LINCOLN PARK PLANNING COMMISSION
CITY HALL – COUNCIL CHAMBERS 1355 SOUTHFIELD ROAD
LINCOLN PARK, MICHIGAN
February 12, 2020 at 7 p.m.

4032 Fort – Carryout Restaurant

Site Plan Review

Applicant	Michael Braskich
Project	Carryout Restaurant
Address	4032 Fort Street, Lincoln Park, MI 48146
Date	February 12, 2020
Request	Site Plan Review
Recommendation	Approve with conditions

FRONT ELEVATION

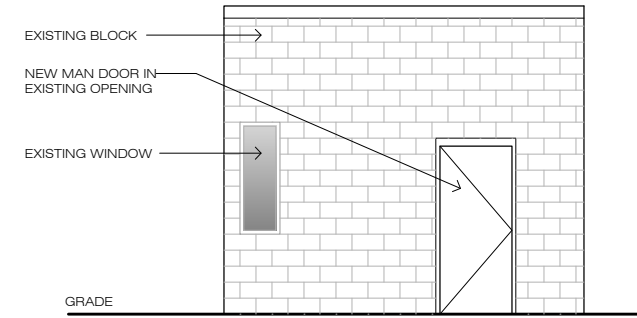
- Applicant shall provide the proposed paint sample/color for the exterior of the existing brick of the front elevation.
- Applicant shall indicate a clear description of the unidentified material of the area above the entry door which replace the location of the existing A.C. window unit.

PROPOSED SITE PLAN

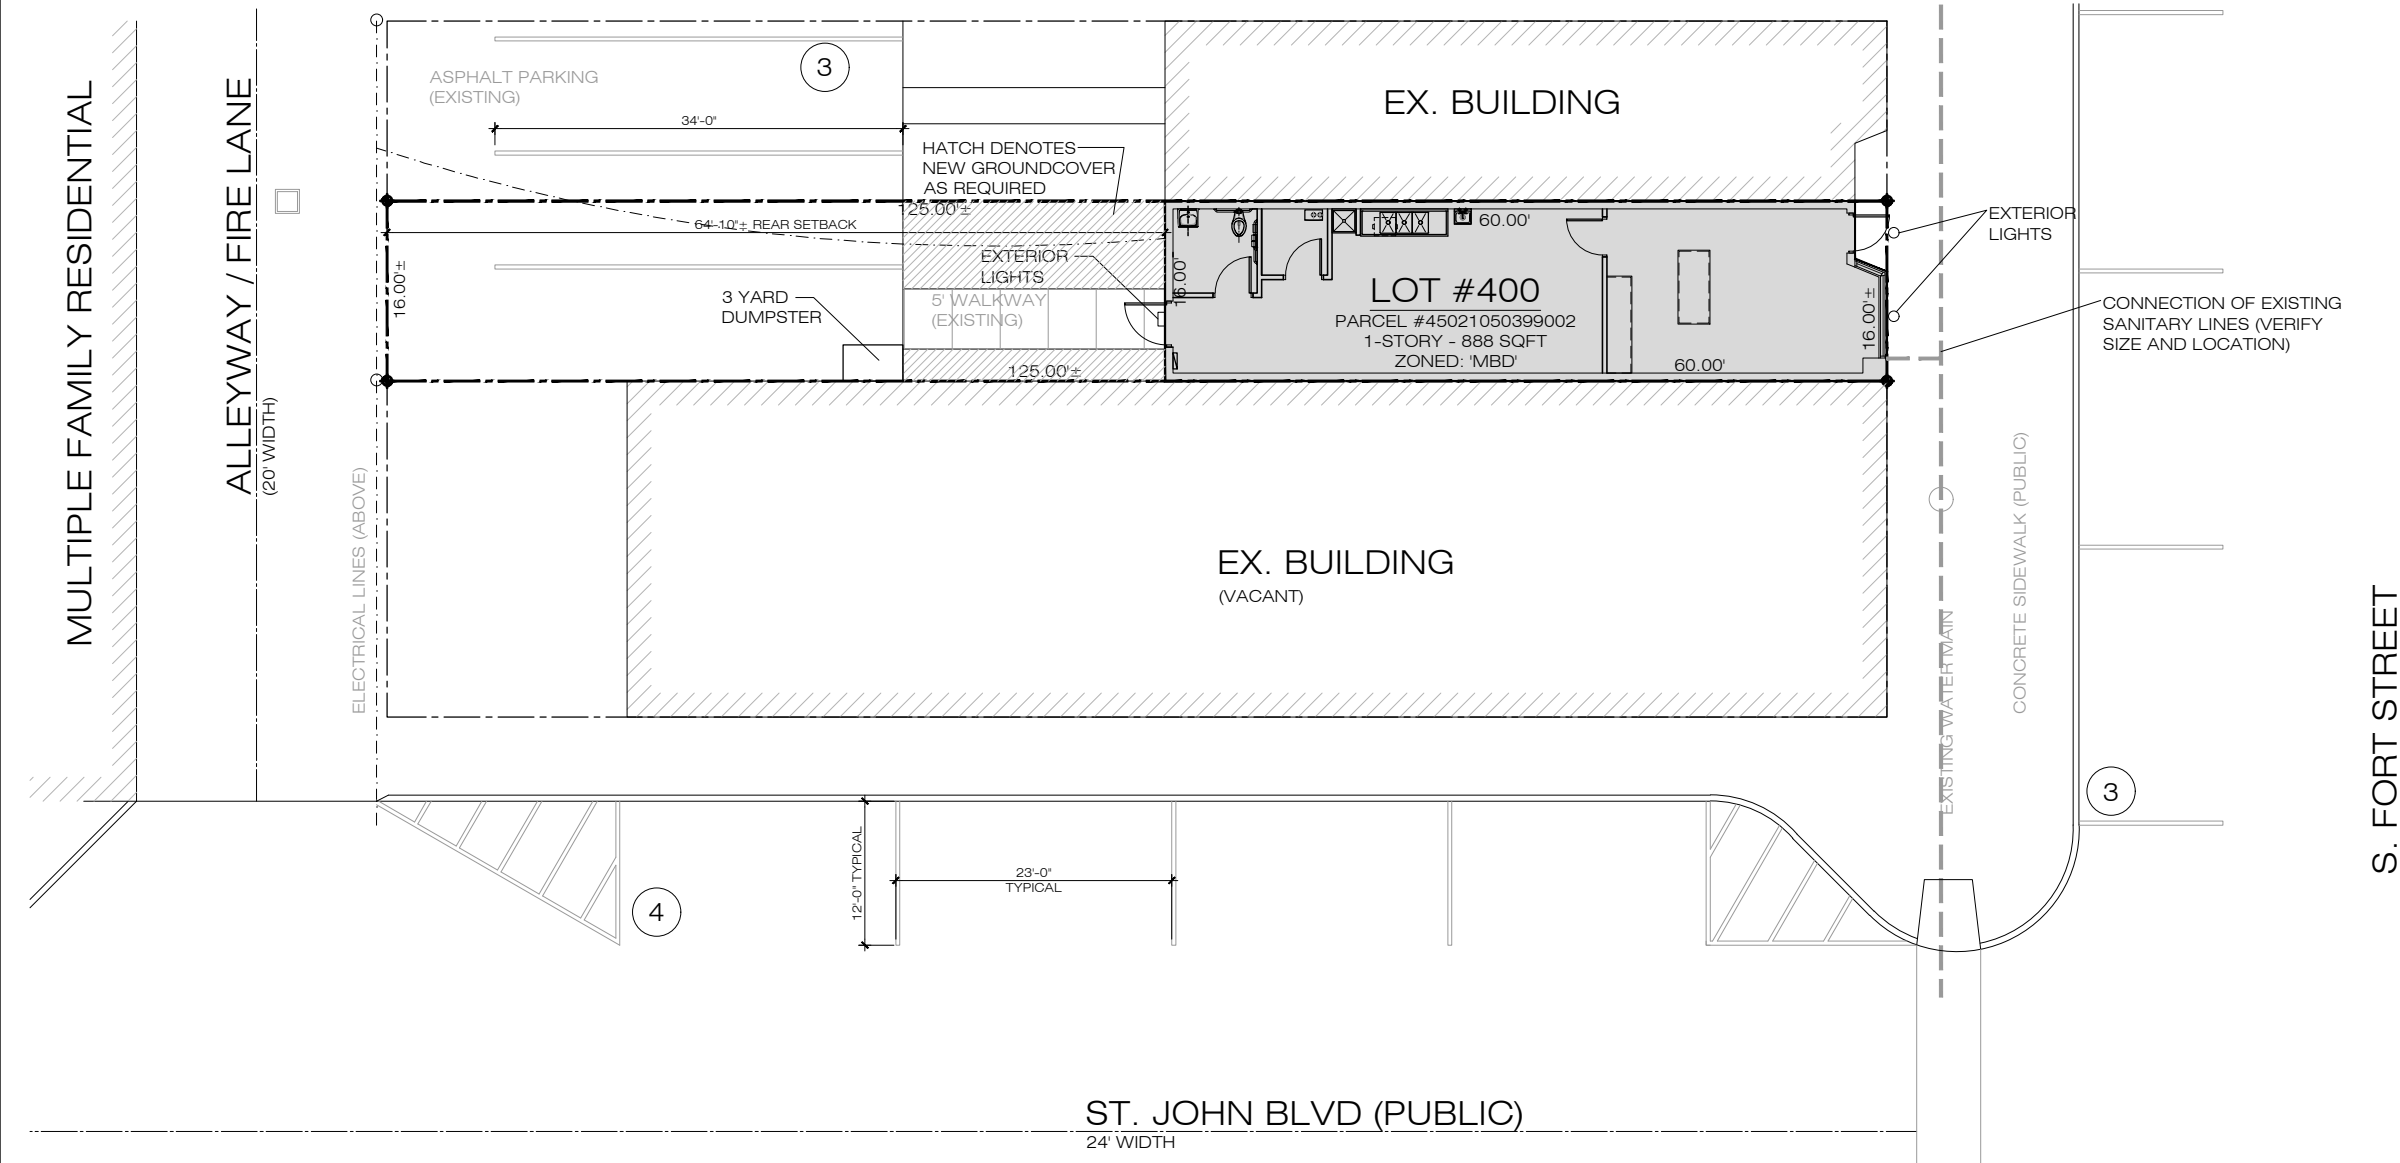
The proposed number of the parking spaces does not comply with the parking requirements for a carryout restaurant. The site plan indicates that ten (10) parking spaces are provided: the three (3) shared parking spaces between the property and adjacent property 4030 Fort St.; three (3) on-street parking spaces on Fort St, and four (4) on-street parking spaces on St. John. Only 1.5 of these spaces can be truly accurately characterized as “provided,” since the remaining 8.5 spaces are off-site and most are not under the direct control of the applicant. This label should be corrected on the site plan.

The site plan shows a 3-yard dumpster abutting the neighboring building to the south, with no indication of the required screening. The dumpster appears to encroach on the walkway between the parking area and the rear door, and may encroach further once repositioned for pickup service.

- *Planning Commission waiver requested to accept the proposed parking plan of 1.5 parking spaces provided on-site to serve employees, and 7 shared on-street parking spaces to serve the four adjoining businesses on the block which do not have private off-street parking facilities.*
- *Applicant shall indicate clearly the concrete curb and gutter lines between the groundcover and sidewalk and the rear parking spaces, and provide the curbs and gutters sectional detail to scale. If the City Engineer determines during detailed engineering review that curbs and gutters are not required for stormwater management, wheel stops may be provided instead.*

- Planning Commission shall determine the appropriate measures to safely accommodate the storage and removal of trash from the site.*
